Global Change Notification (GCN)

Product Family

GCN Number

Series

Series image - Reference only

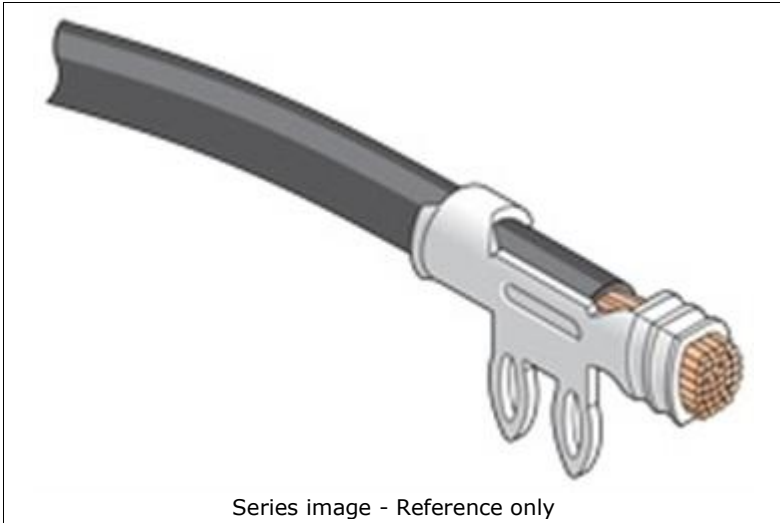
Change Description
